## PRODUCT / PROCESS CHANGE INFORMATION

1.1 Company		STMicroelectronics International N.V
1.2 PCI No.		MDG/20/11911
1.3 Title of PCI		ST25R, NFC Reader IC family (ST25R3911B / ST25R3916) Pb-free category symbol marking change
1.4 Product Category		ST25R3911B-AQFT ST25R3916-AQWT
1.5 Issue date		2020-01-09

### ST25R, NFC Reader IC family (ST25R3911B / ST25R3916) Pb-free category symbol marking change

**- DEVICE MARKING**

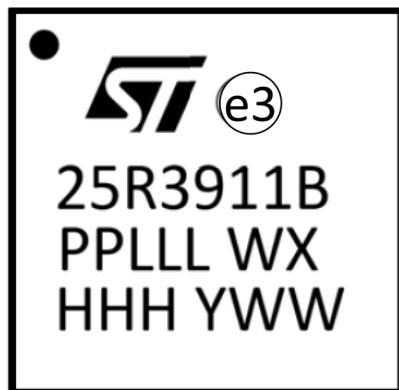
The device marking will show Pb-free category symbol from “e4” to “e3” from January 2020.

Example:  
ST25R3911B  
old marking

Example:  
ST25R3911B  
new marking
